Access Compliance Report

Public Rights-of-Way

Intersection ID: 10019463	Main Street: ALEXANDER MARTIN AV	Cross Street: N/A	Location: NE
ADA ID: F75A18D574D6	Ramp Type: BlendTrans2	Initial Pass/Fail: Pass	Overall Compliance: No
			Severity Score: 10.25

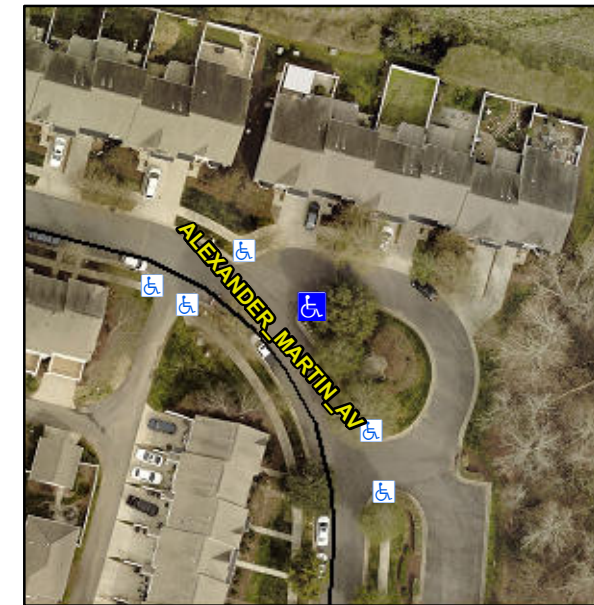
Not Found, R304.5.3, R305

Remove & Replace Curb Ramp With Two New Directional Ramps or Equivalent. Remove & Replace Gutter.
